# UNITED STATES PATENT AND TRADEMARK OFFICE

APPLICATION NO.	FILING DATE	FIRST NAMED INVENTOR	ATTORNEY DOCKET NO.	CONFIRMATION NO.
10/731,770	12/09/2003	Roger E. Ahnkiel	38190/270312	4264

## Office Action Summary

## **DETAILED ACTION**

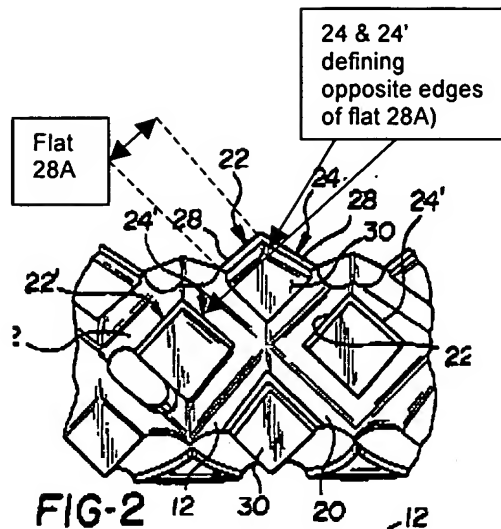
cutting teeth (first and second) (22, 22' and, 24 & 24') disposed peripherally about a first/right hand helix (20) that intersects a second left hand helix (18) (Col. 2, lines 60-65 & figure 1). Campian also teaches cutting teeth having cutting clearance and non-cutting clearance on both the first and second cutting edges and first and second non-cutting edges (Col. 2, lines 1-2 and Col. 3, lines 9-14). Figures 1 and 2 show smooth transition between the first cutting edge of one cutting tooth (22) and first non-cutting edge of an adjacent cutting tooth (22') (the same applied to second cutting edge of one cutting tooth (24) and second non-cutting edge of an adjacent cutting tooth (24')). Furthermore, Campian teaches overlapping cutters (22 & 24 and 22' & 24') defined by the lands (flats) (28) that result in circular flat on the outside diameter (Col. 3, lines 29-38). The first cutting and non-cutting edges of cutting tooth (22) extend radially outward to define a length of the flat (28A) and the second cutting and non-cutting edges of cutting tooth (24 & 24') extend radially outward to define opposing edges of the flat (28A) (see diagram below). Additionally, Campian teaches right hand (first) and left hand (second) flutes having helix angle in the range of 30-60 degrees to the axis of the cylindrical body of the tool shank (Col. 1, lines 61-65) which meets the limitation of about 30 degrees for first helix and about -30 degrees for the second helix, claimed in claims 7 and 19.
